## ArevaEPRDCPEm Resource

**Response to  
Request for Additional Information No. 537  
Supplement 1**

**U. S. EPR Standard Design Certification  
AREVA NP Inc.  
Docket No. 52-020  
SRP Section: 06.02.01 - Containment Functional Design  
Application Section: 6.2.1**

**Question 06.02.01-104:**

Figure 3D-1—Typical Combined LOCA/SLB Inside Containment Temperature Service Conditions Envelope

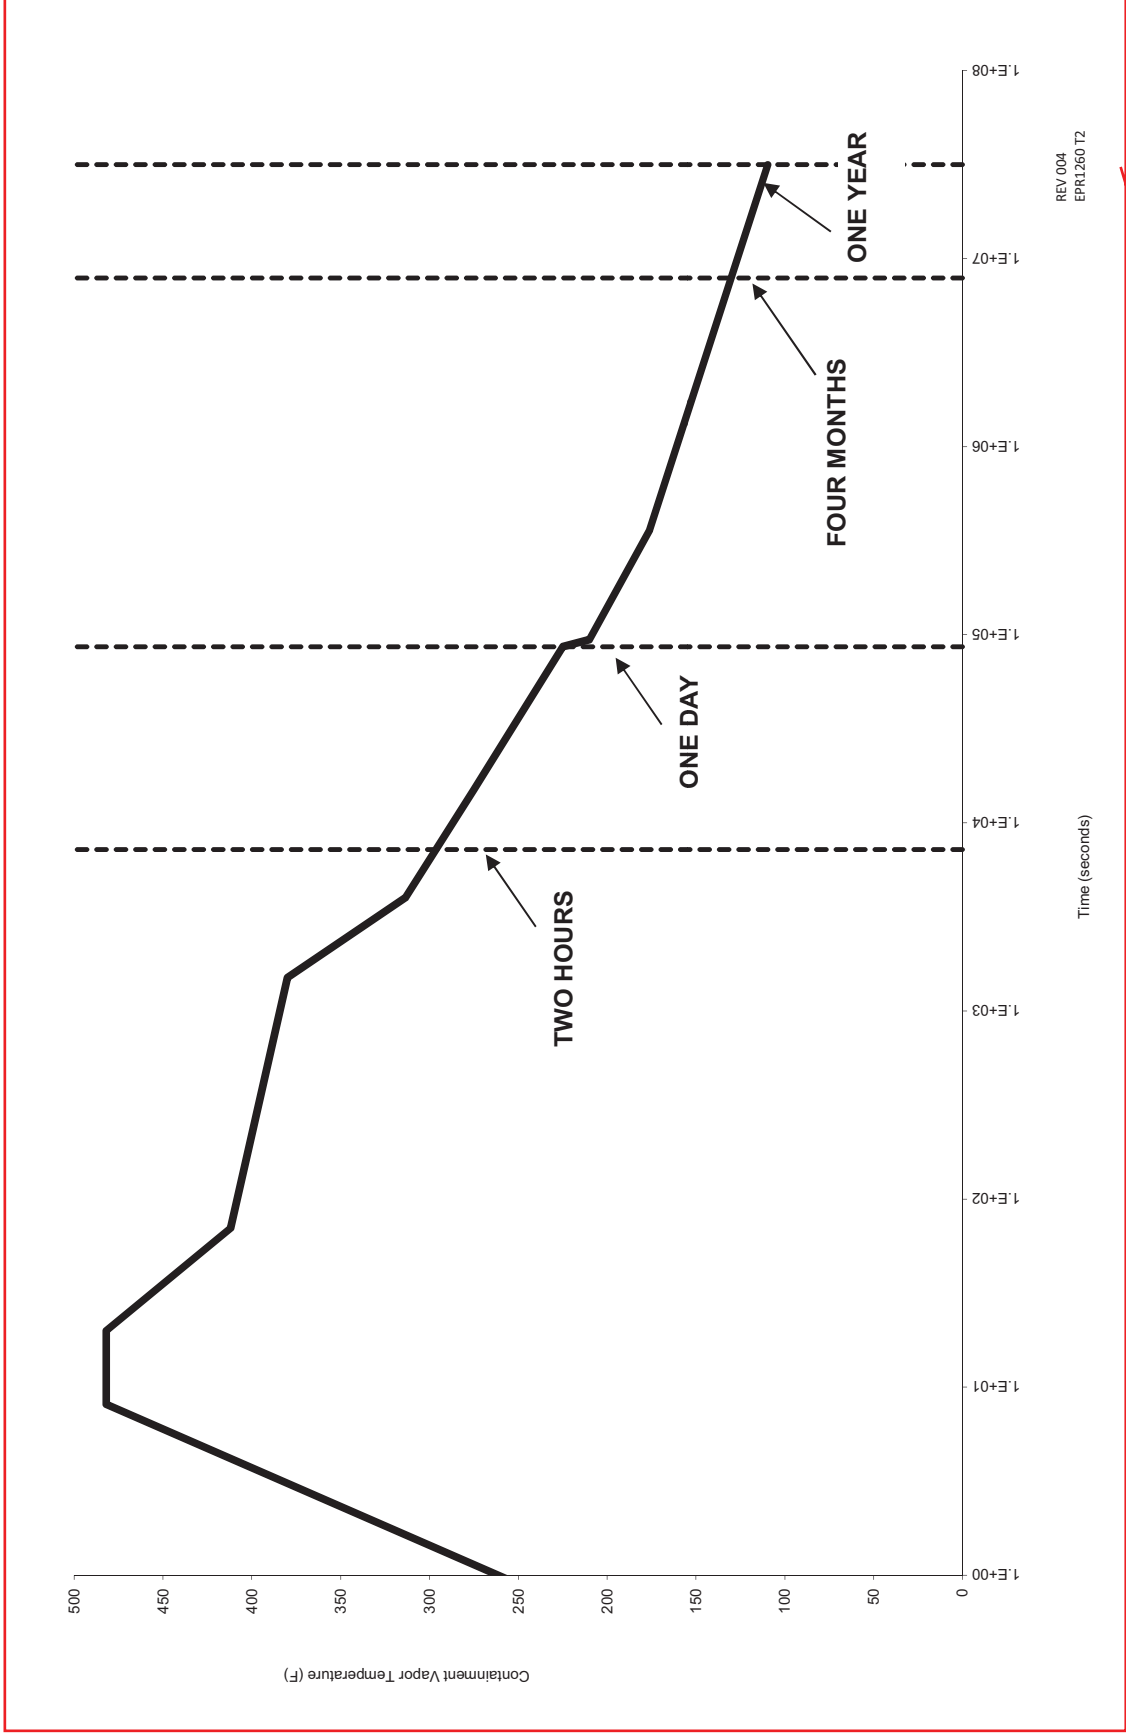
Non-conservative EQ Temperature Envelope in Tier 2 FSAR (Rev. 3).

The information as provided in the RAI No. 368, Supplement 10 response for Question 06.02.01-80, Table 06.02.01-80-1 and Figure 06.02.01-80-1, presents the bounding temperature envelope for environmental qualification that captures all LOCA and MSLB cases. The RAI response concludes that the FSAR will not be changed as a result of this question. Staff notes, the EQ temperature curve as shown in Figure 3D-1 of Tier 2 FSAR Rev.3 is significantly non-conservative as compared to the temperature envelope provided in this RAI response. Staff requests the applicant address the non-conservatism of FSAR Rev.3 EQ temperature curve (Figure 3D-1) against this RAI response and resolve their inconsistency.

U.S. EPR FSAR Tier 2, Appendix 3D, Figures 3D-1 and 3D-2 will be revised to reflect the revised temperature and pressure envelope as a result of the response to RAI No. 368, Supplement 10.

U.S. EPR FSAR Tier 2, Appendix 3D, Figures 3D-1 and 3D-2 will be revised as described in the response and indicated on the enclosed markup.
